Staff Report

Re: PLNSUB2017-00346 and -00347 Cottam Acre Planned Development / Preliminary Subdivision Plat

PROPERTY ADDRESS: 1463 W. Van Buren Avenue

REQUEST: Applicant requests approval of a proposed planned development and related preliminary subdivision plat creating three residential lots from one existing lot. The planned development review pertains to the creation of a "flag lot" and building setback reductions for the flag lot. Another modification sought is to increase the flag lot size to exceed the allowed maximum size of the zoning district; this is done through the subdivision review process. The Planning Commission has final decision making authority for planned development applications and preliminary plat applications.

A0.2

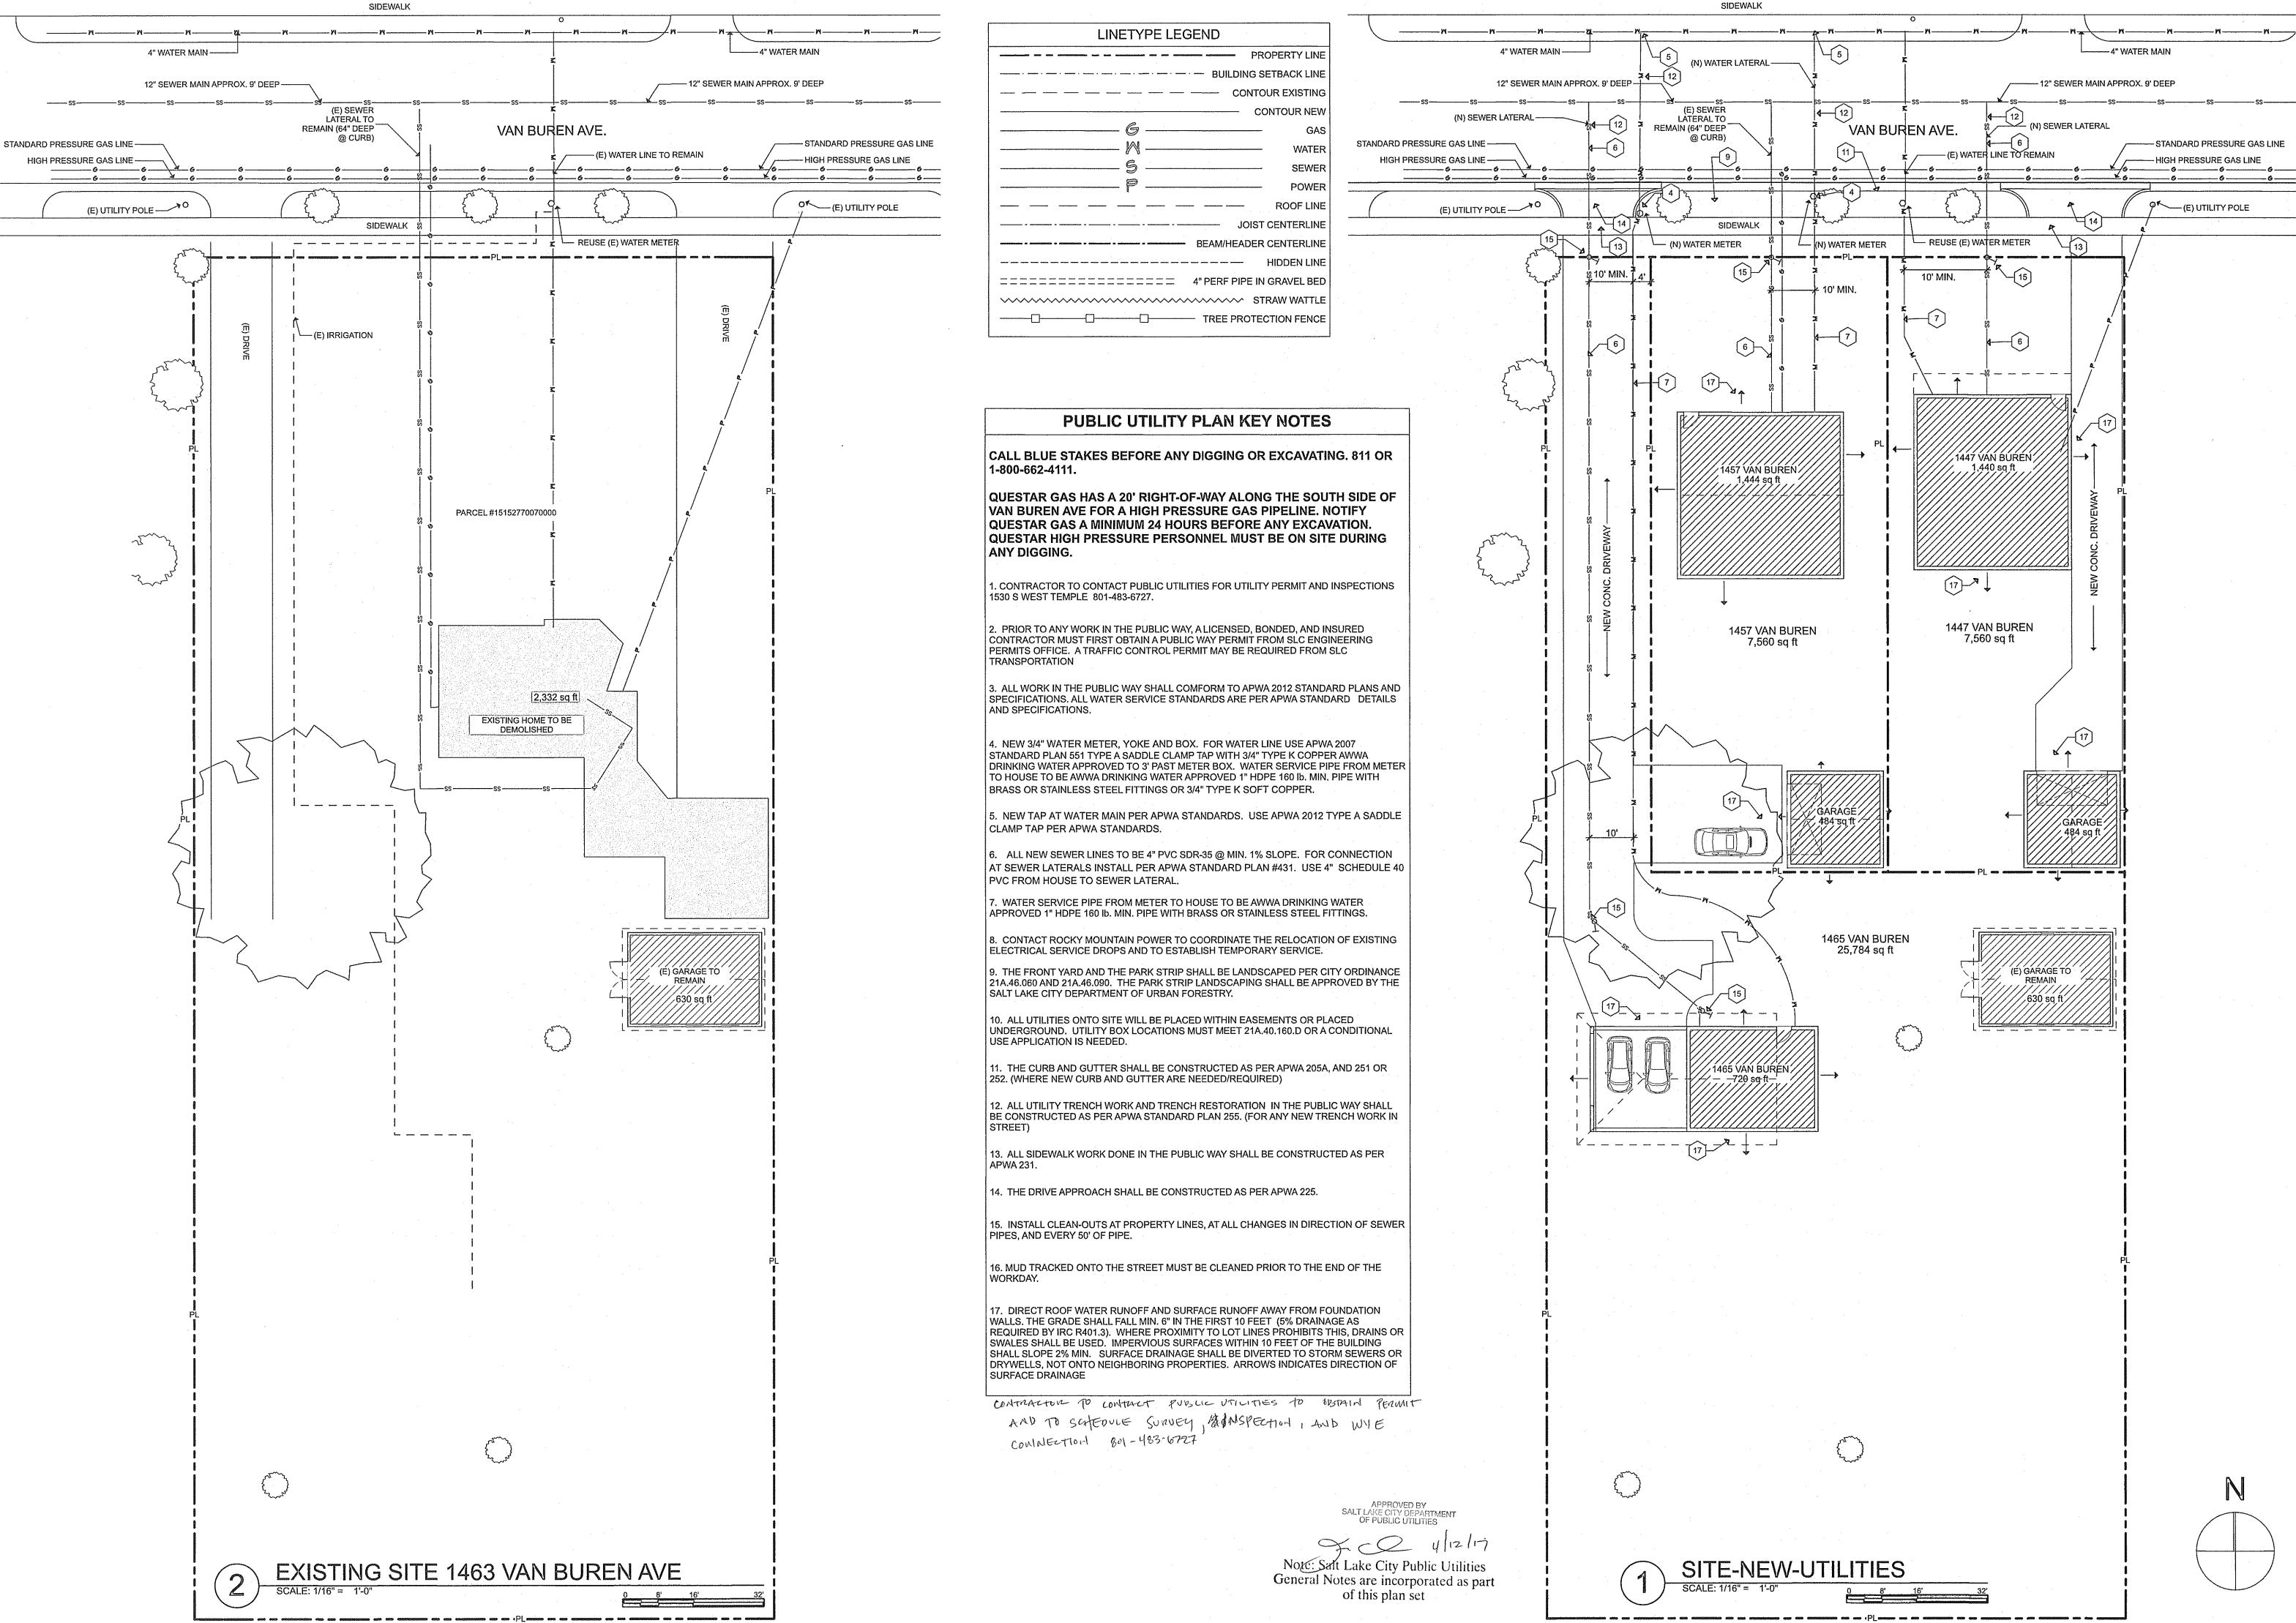
The existing east lot line conflicts with an accessory building on the adjacent lot to the east. The applicant plans to resolve the neighbor's building encroachment by jogging the line around the building (trading portions of property) to locate the building clearly on the neighbor's property. This item is included as a recommended condition if the project is approved.

- The minimum depth of the front yard for all principal buildings shall be equal to the average of the front yards of existing buildings within the block face, however; where the minimum front yard is specified in the recorded subdivision plat, the requirement specified on the plat shall prevail. It would be my suggestion that the average of the front yards of existing buildings within the block face be determined and the buildable area be identified for the planned development/subdivision and future development of each lot; keeping in mind that for flag lots, the front yard shall begin at the point where the access strip joins the main body of the lot

- 21A.24.010 G.9 for flag lots states that "If any portion of the structure exceeds one story in height, **all** side yard setbacks shall meet the required **rear yard setback** of the underlying zoning district" (25' in this case). Because this proposal is suggesting a modification of this requirement, it would be my suggestion that the buildable area be identified for the planned development/subdivision and future development of the flag lot. Note: 21A.55.040: LIMITATION states: No change, alteration, modification or waiver authorized by section 21A.55.030 of this chapter shall authorize a change in the uses permitted in any district or a modification with respect to any standard established by this chapter, or a modification with respect to any standard in a zoning district made specifically applicable to planned developments, unless such regulations expressly authorize such a change, alteration, modification or waiver.

- 21A.24.010 G.11 states that on a flag lot "Any garage, whether attached to or detached from the main building, shall be located in the buildable area of the lot." Because this proposal is suggesting a modification of this requirement, it would be my suggestion that any modified buildable area be identified for the planned development/subdivision and future development of the flag lot. Note: No change, alteration, modification or waiver authorized by section 21A.55.030 of this chapter shall authorize a change in the uses permitted in any district or a modification with respect to any standard established by this chapter, or a modification with respect to any standard in a zoning district made specifically applicable to planned developments, unless such regulations expressly authorize such a change, alteration, modification or waiver.

- 21A.24.010 G13 states that on a flag lot "A four foot (4') wide landscaped strip is required along both side property lines from the front to rear lot lines." A landscape plan and irrigation plan for the planned development should be provided for review of this required landscaping, the required park strip landscaping, the required front yard landscaping of each lot, and showing compliance with 21A.48.

- 1. The zoning and subdivision requirements approved for modification are: creation of the flag lot as proposed and front yard location for the existing accessory building on flag lot.
- 2. Revise the east lot line of the subdivision to resolve the encroachment of the neighboring accessory building.
- 3. Provide a copy of the final Passive House Institute certification for the dwelling proposed on the flag lot.

NORTH ELEVATION- FLAG LOT HOME

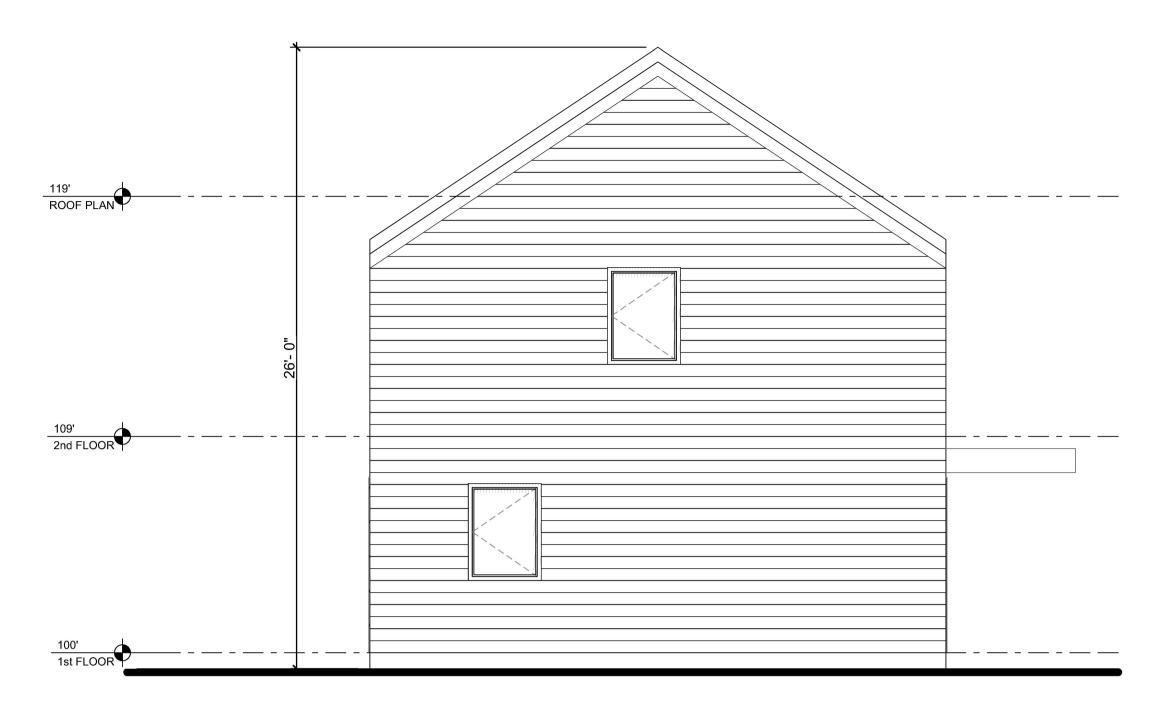
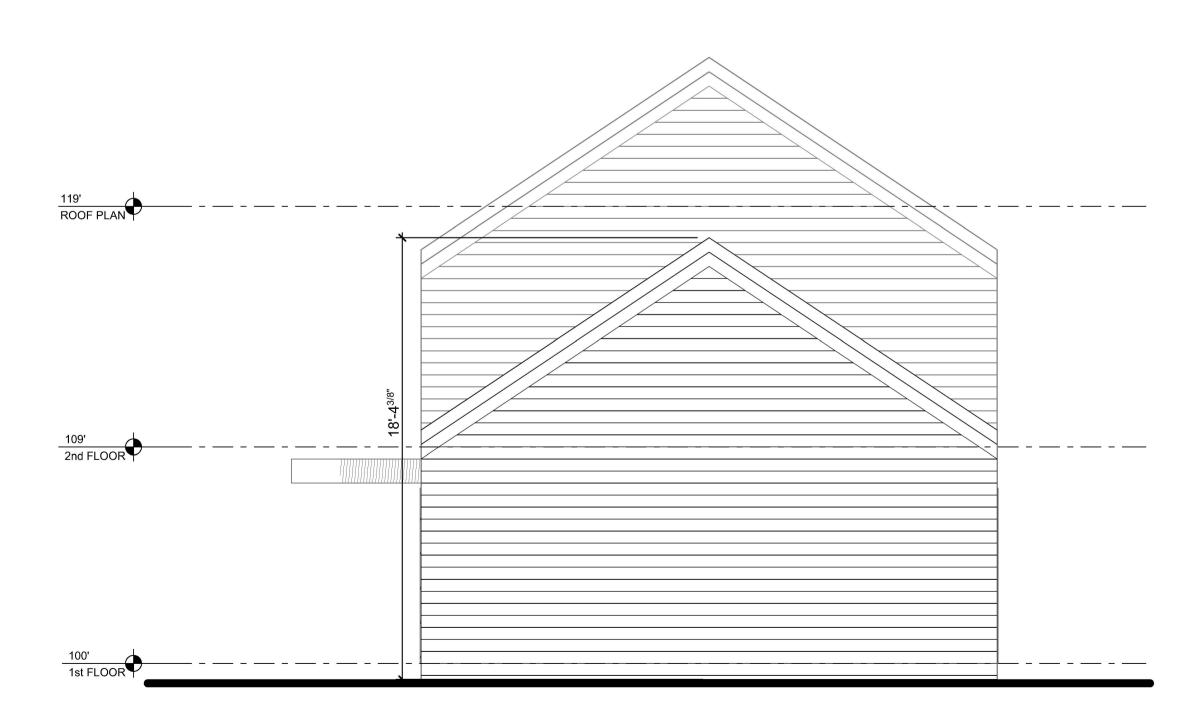
The applicant proposes to building a new single family dwelling that be two-stories in height. A specific regulation for flag lots (21A.24.010.G.9) stipulates that the side yard setback be equal to the rear yard setback, 25 feet in this case, for two story buildings. The applicant requests approval for a 10-foot side yard setback instead. The applicant's reasoning is to maintain similar side yard setbacks of neighboring properties and to allow the distinct grouping of accessory buildings to the east without the dwelling diluting that grouping.

Staff deems the proposed flag lot of sufficient size, more than double the allowed maximum, to allow the new dwelling to easily comply with the 25-foot side yard setback. Staff finds no reason to support the reduced side yard setback and staff's recommendation on page one of this report reflects that, specifically <u>condition #1</u>.
